ADDENDUM #4

TO: Potential Offerors  
FROM: Cora Shirai, Contract Manager  
RE: Solicitation Addendum #4 to RFP #22-01/Imaging Department Renovation

See G70 Addendum 3 (attached) for KVMH and SMMH Imaging Department Renovations. Changes include adding supports for the chest stands at the x-ray rooms and clarifying the dimming devices for lights.

**KVMH IMAGING DEPARTMENT RENOVATIONS**

**A ARTICULATING ARM MOUNT FRAMING (CONCEPTUAL)**  
S202 SCALE: 3/4" = 1'-0"

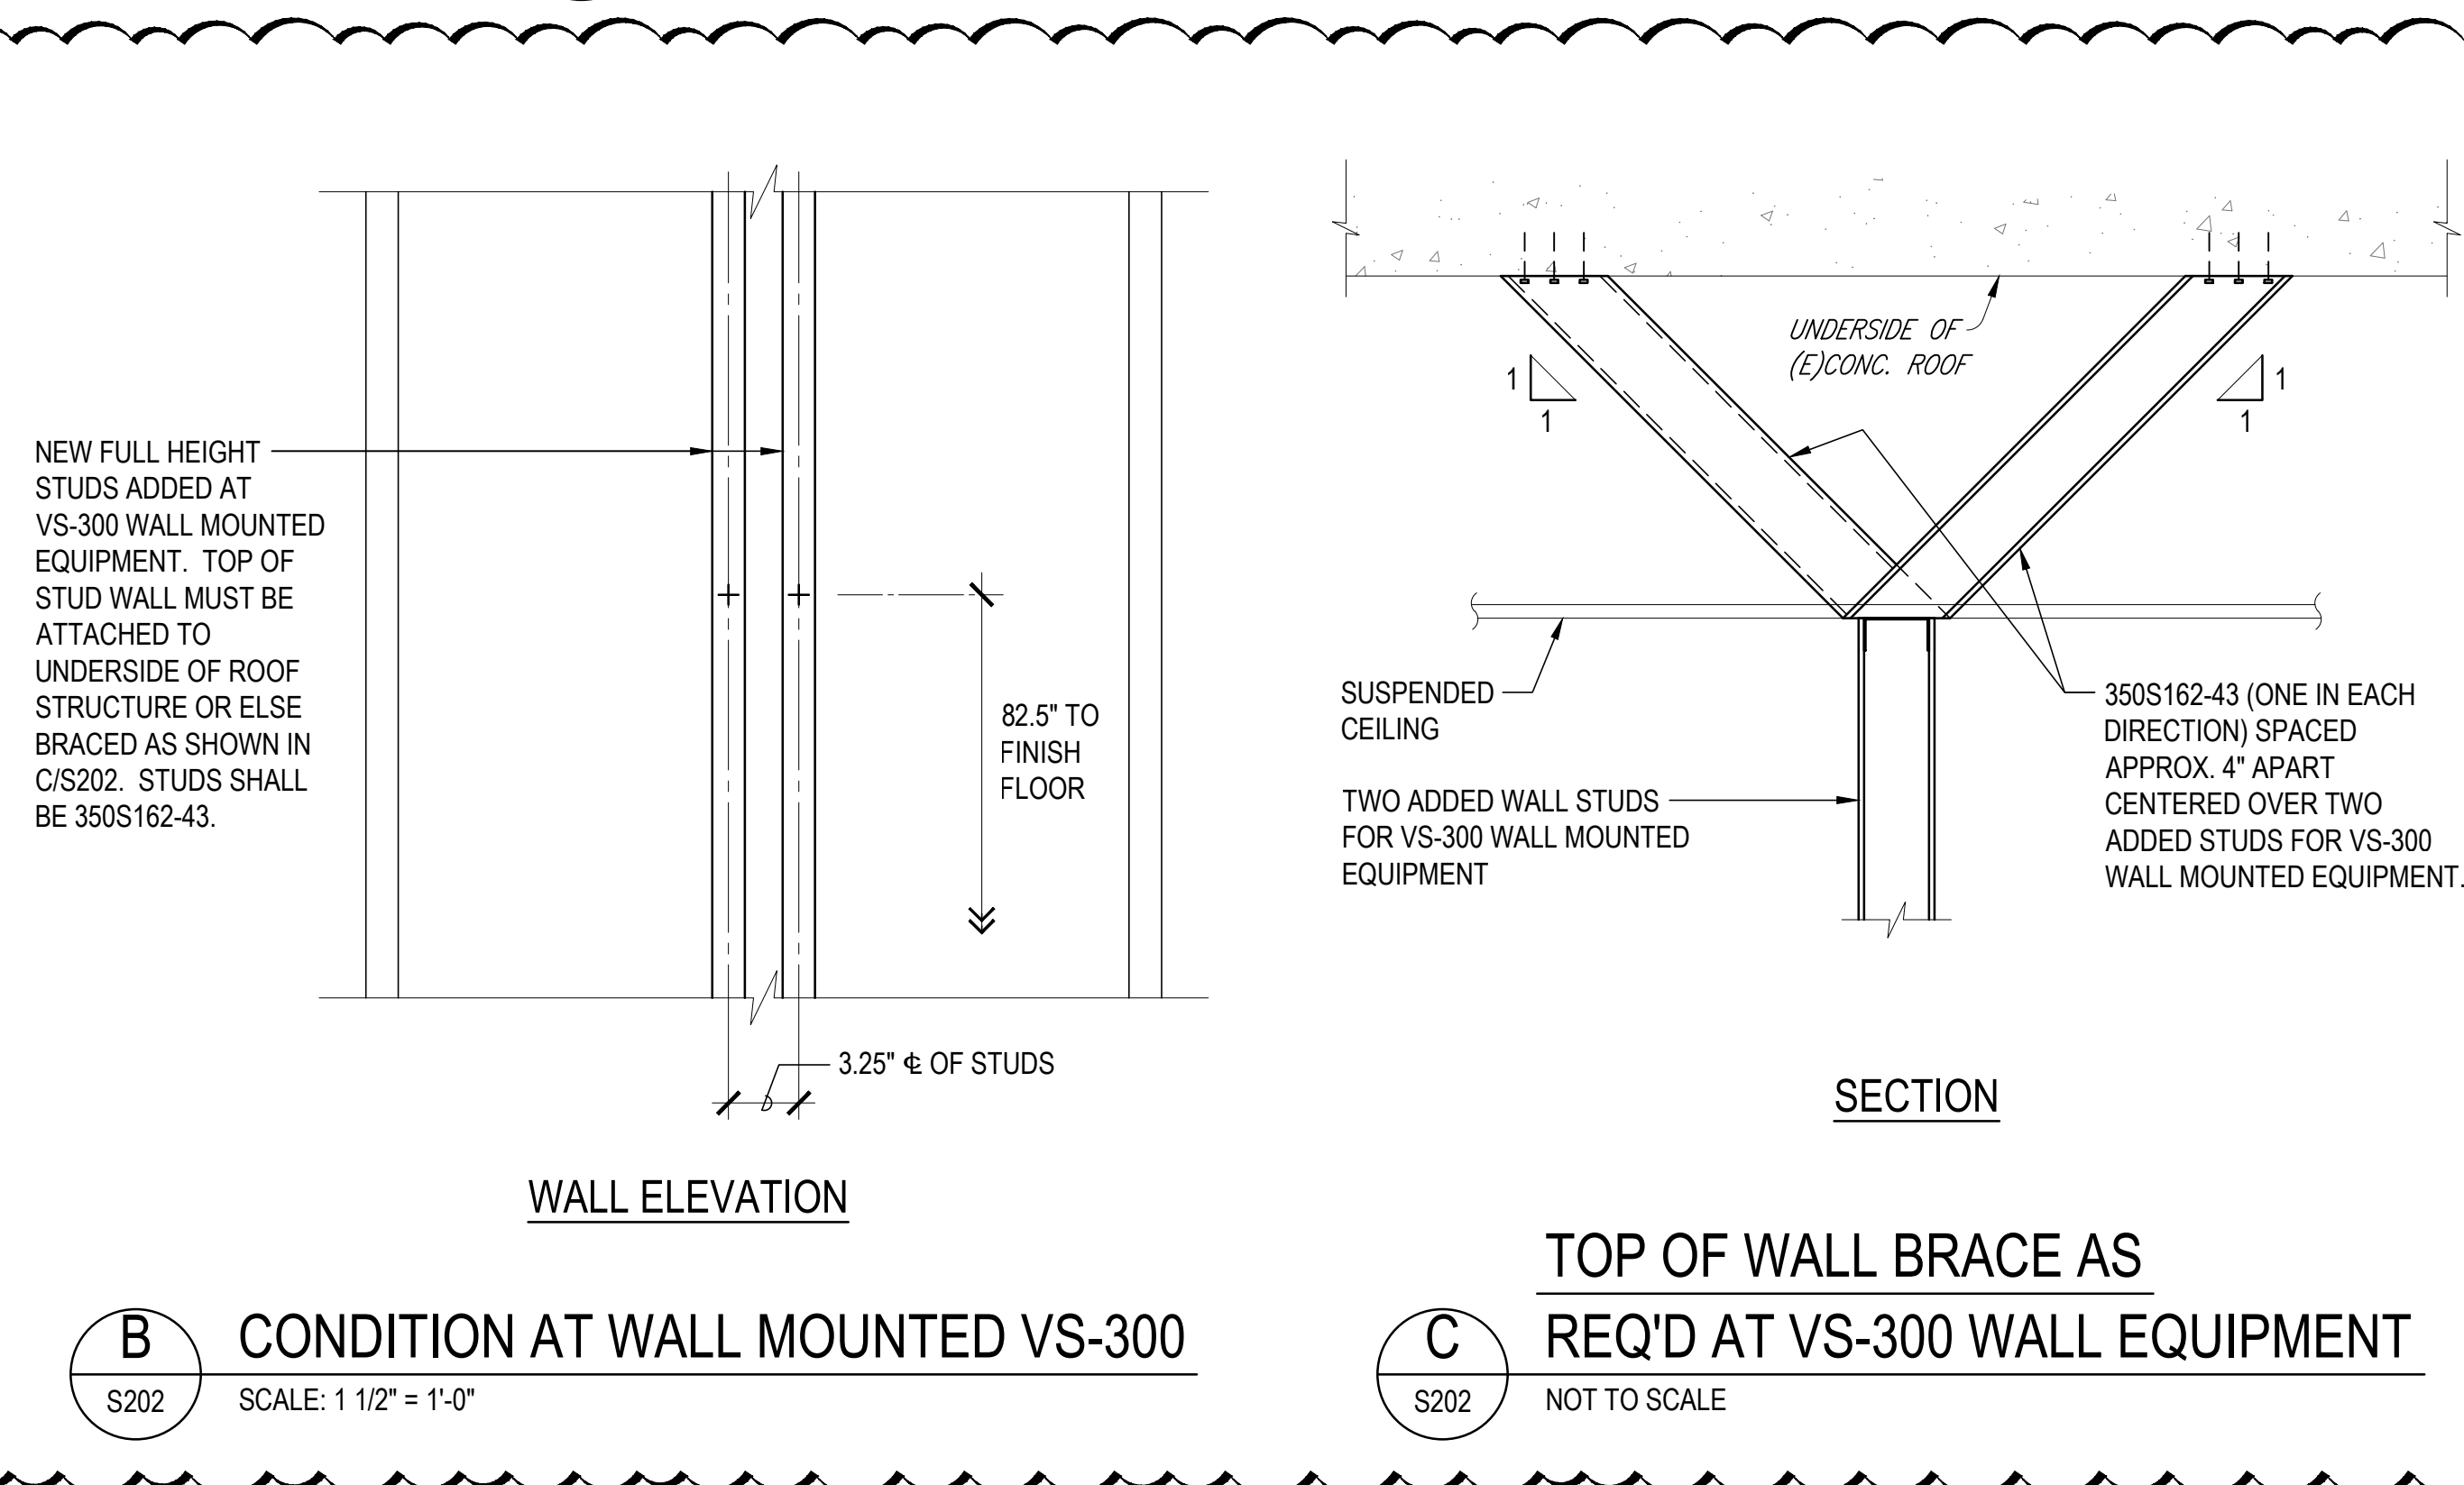
Drawing No.	Delta No.	Description
S201	3	Added details
S202	3	Added details

**B CONDITION AT WALL MOUNTED VS-300**  
S202 SCALE: 1 1/2" = 1'-0"

**C TOP OF WALL BRACE AS REQ'D AT VS-300 WALL EQUIPMENT**  
S202 NOT TO SCALE

**EXISTING BEAM RETROFIT**

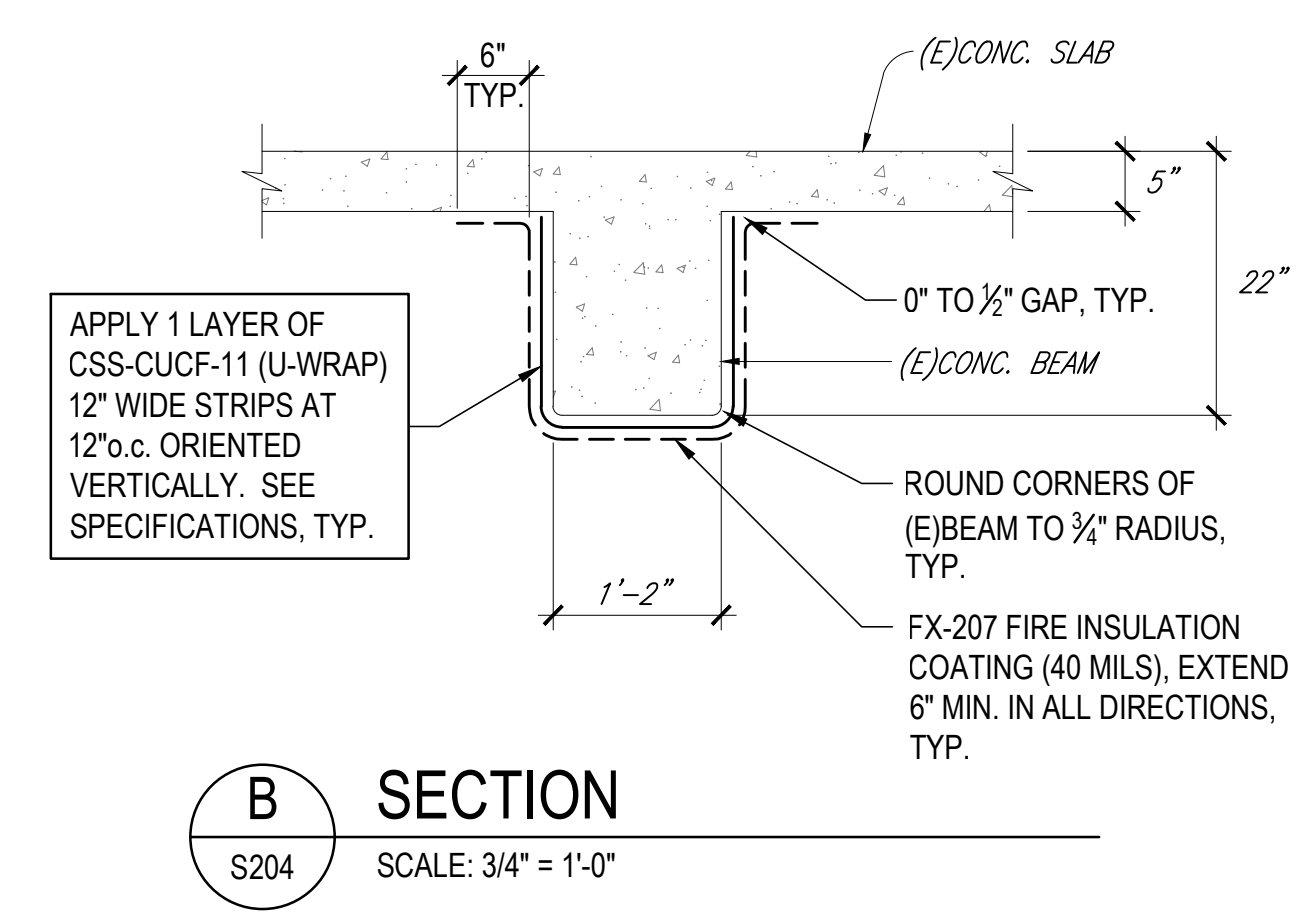
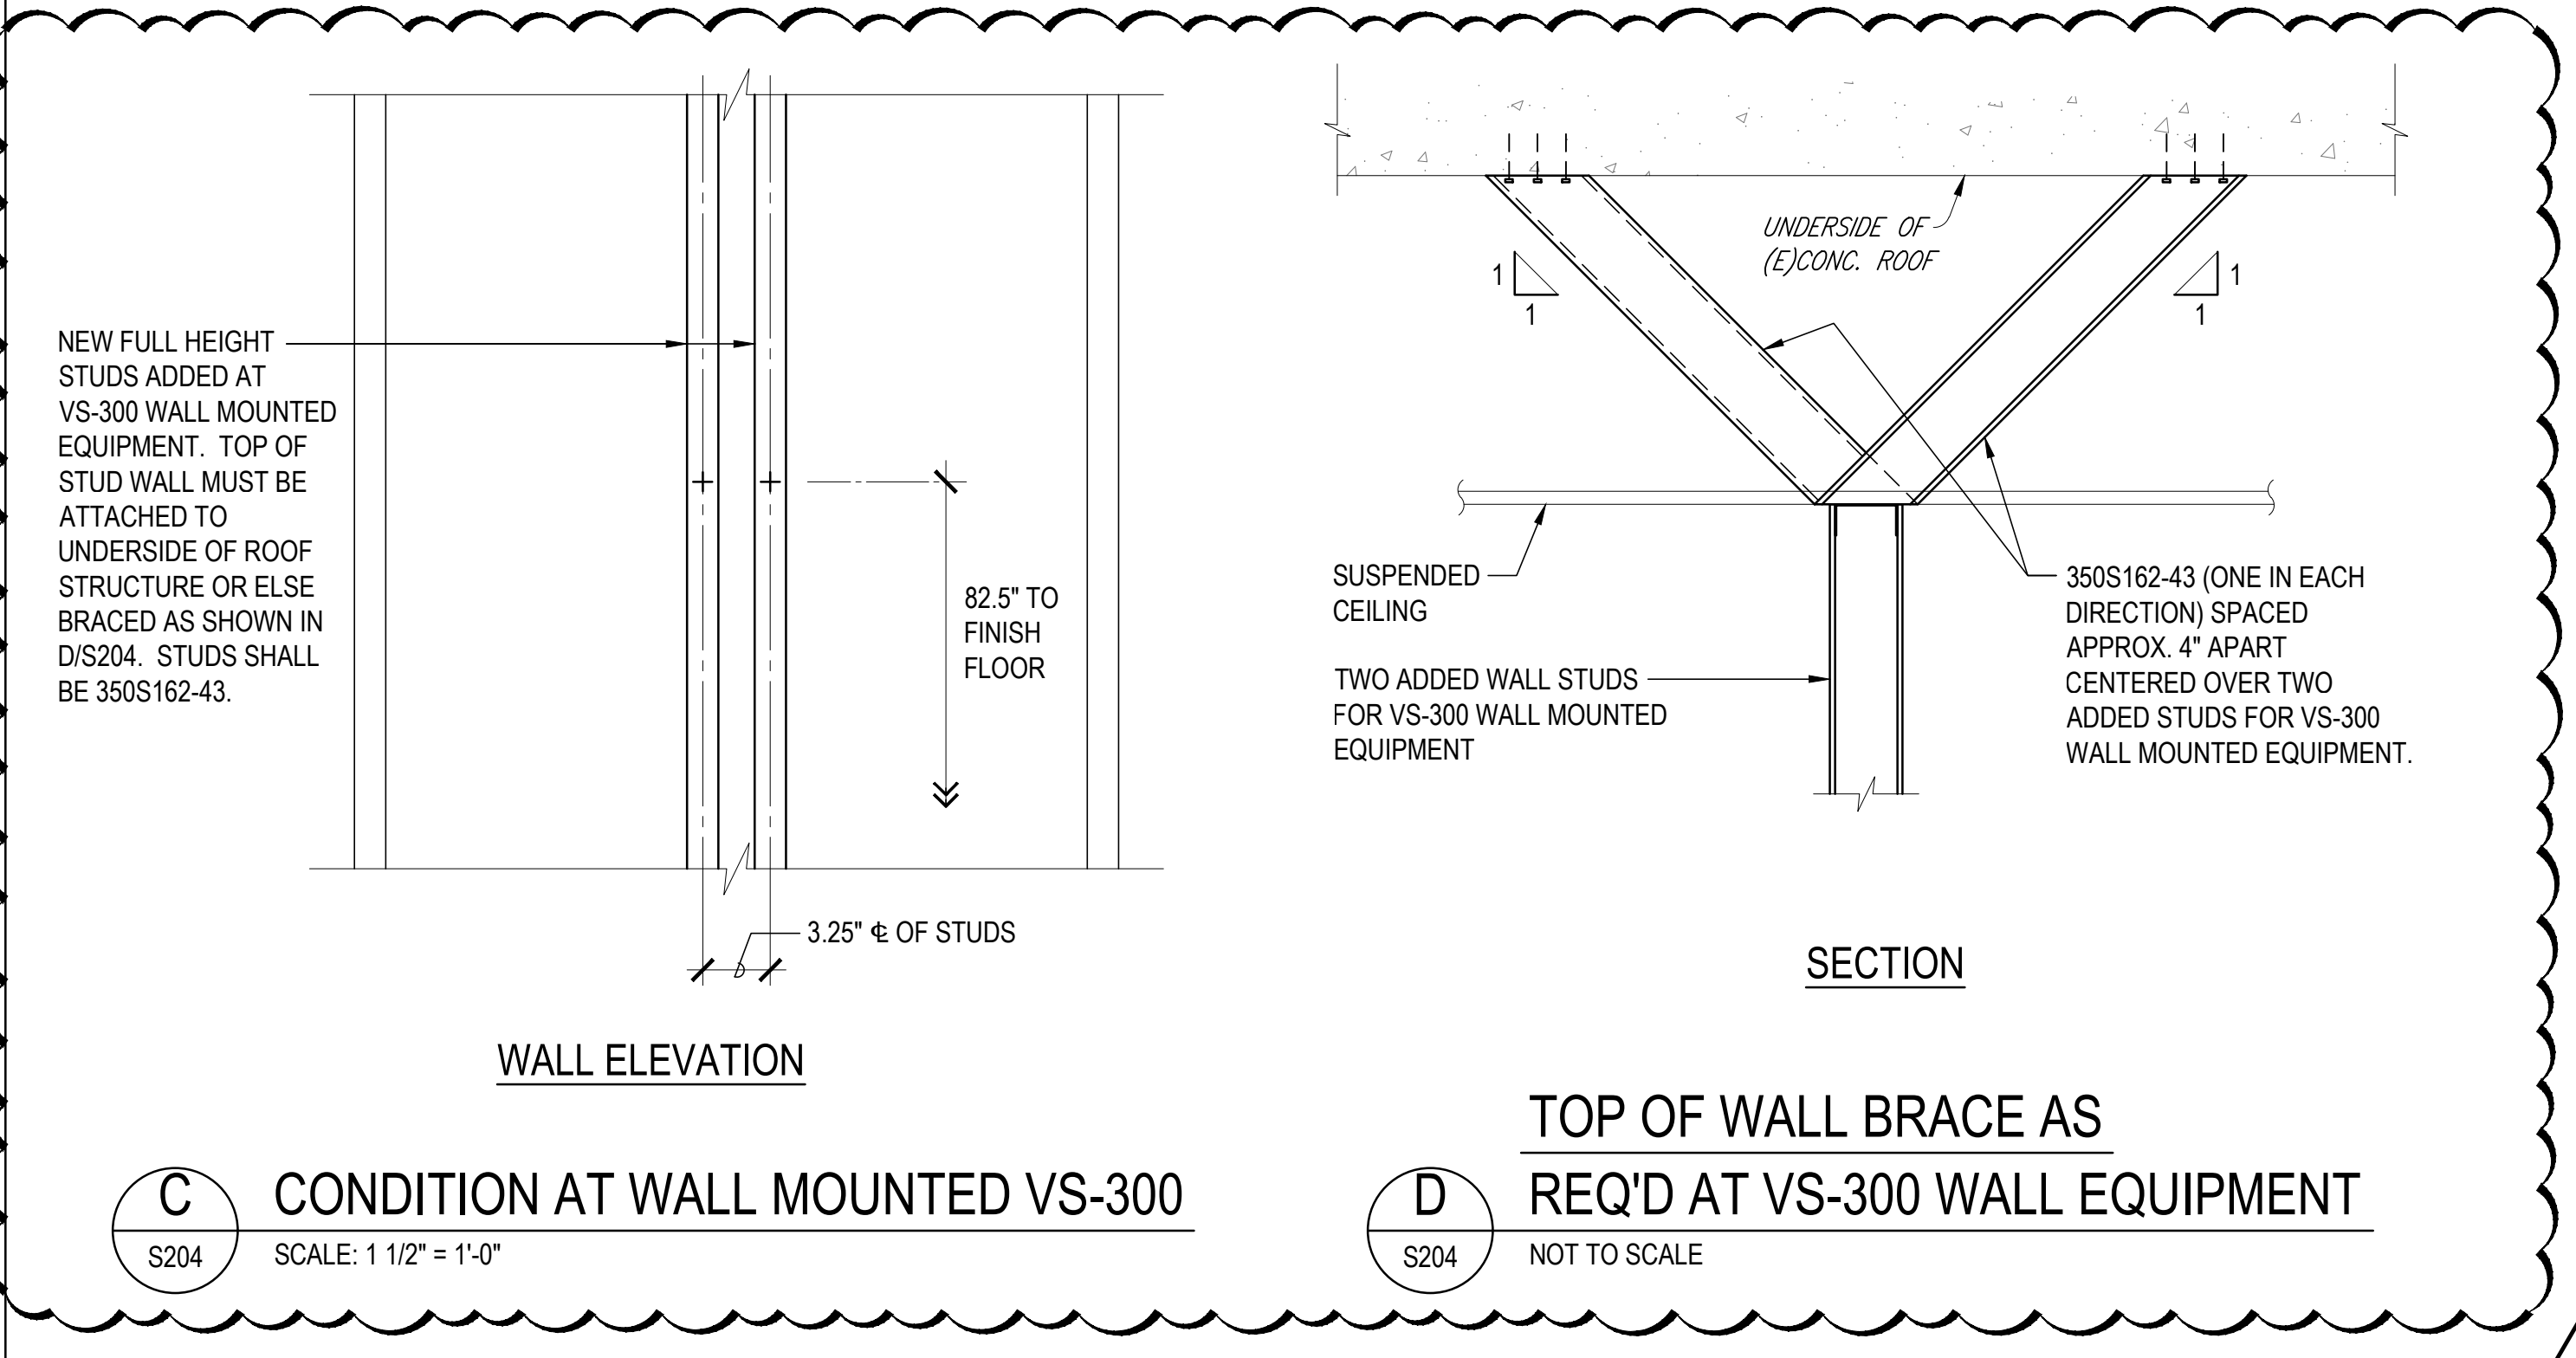
Drawing No.	Delta No.	Description
S201	3	Added details
S204	3	Added details

**A** ELEVATION OF EXISTING CONCRETE BEAM ALONG GRIDLINES 1.5 & 2  
S204 SCALE: 1/2" = 1'-0"

**B** SECTION  
S204 SCALE: 3/4" = 1'-0"

**C** CONDITION AT WALL MOUNTED VS-300  
S204 SCALE: 1 1/2" = 1'-0"

**D** TOP OF WALL BRACE AS REQ'D AT VS-300 WALL EQUIPMENT  
S204 NOT TO SCALE
